Project Title: TLC Plumbing Co.

Re: **TLC Plumbing Office, Grading and Drainage Plan**
Engineer's Stamp dated 10-08-04 (G15-D62)

**Re: TLC Plumbing Office, 5030 Edith Blvd NE, Traffic Circulation Layout
Architect's Stamp undated (G15-D62)**

Re: TLC Plumbing Office, Traffic Circulation Layout (G15-D62)

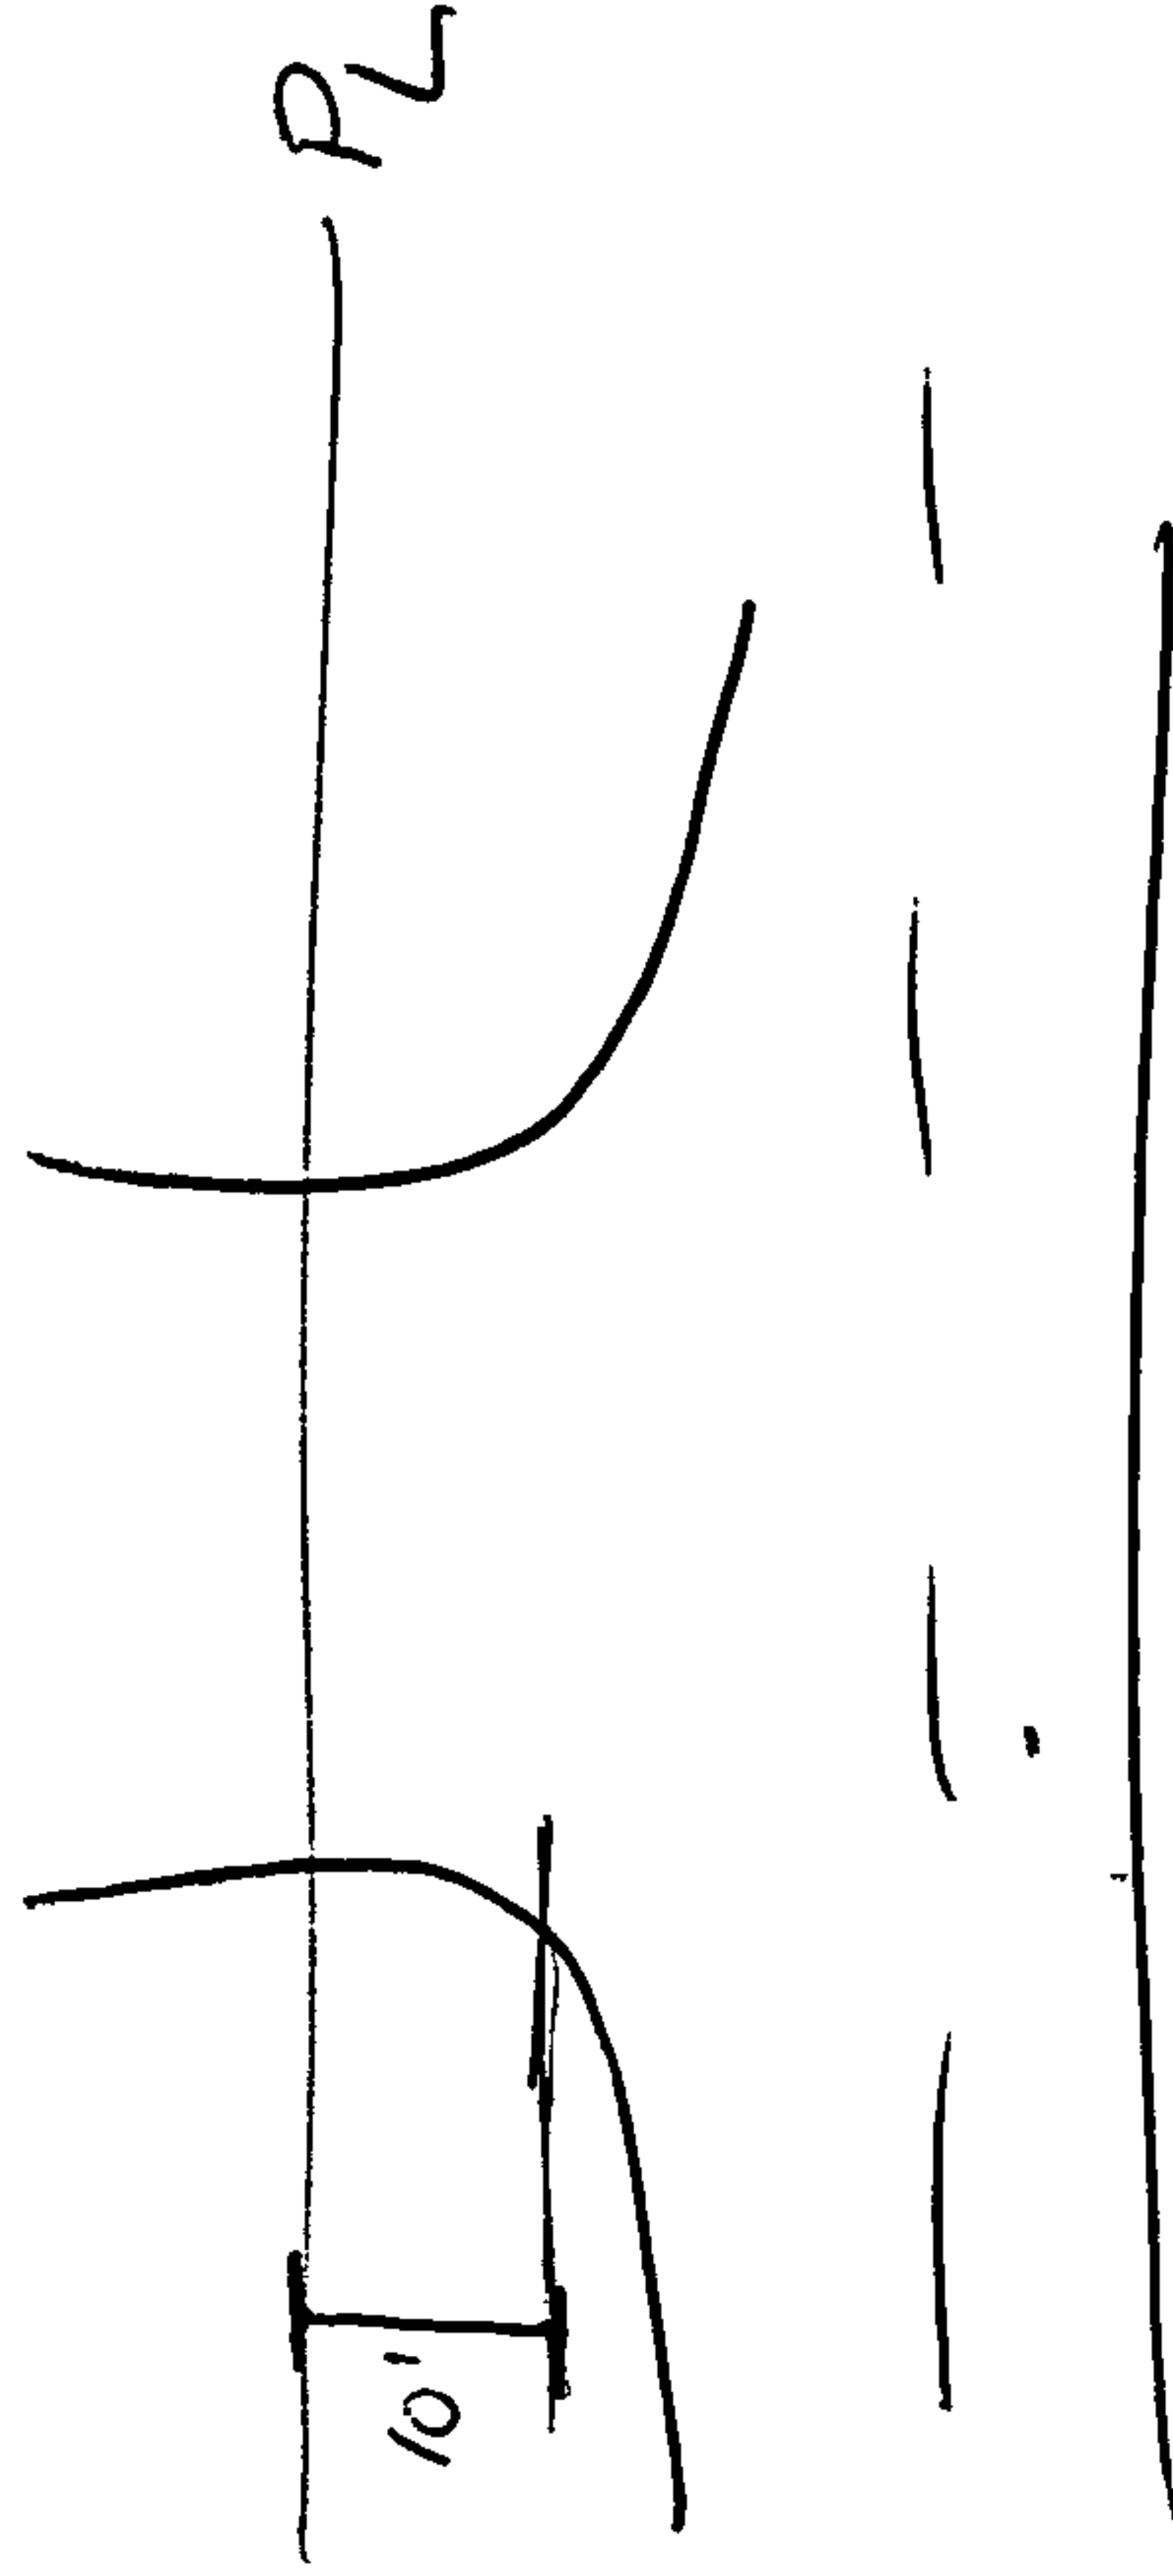
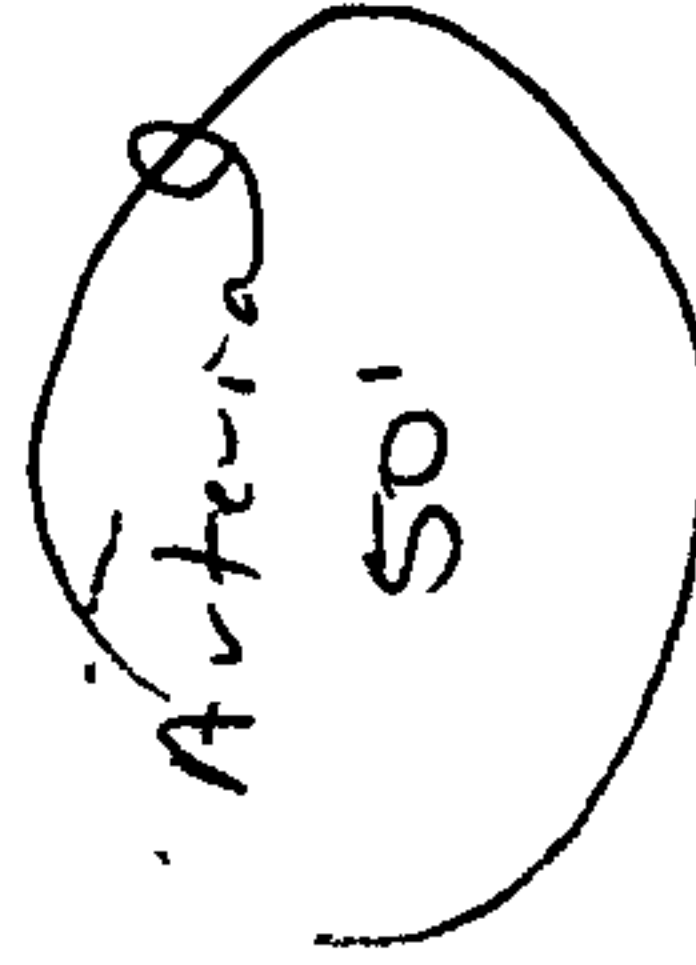
~~1.~~ The handicapped spaces must be a minimum of 8.5 feet in width with an 8-foot wide van access aisle.

3. The traffic circulation layout must be stamped, signed, and dated by an engineer or architect licensed in the state of New Mexico.

8. A five-foot paved keyway is required for deadend parking aisles. *Call out keyway*
~~9.~~ If the site has left turn access, the drivepad has a 36-foot minimum width. If not, the drivepad has a 30-foot minimum width.

60' can't overlap w/ 2ft overhang
If you have any questions, you can contact me at 924-3991.

5' aisle R- HC

Need 8' aisle for HC spaces

5' key way
paved

Arterials - curb returns encouraged

~~2-way drives have 30' min for rt turn only~~
~~36' min for lt + rt turns~~
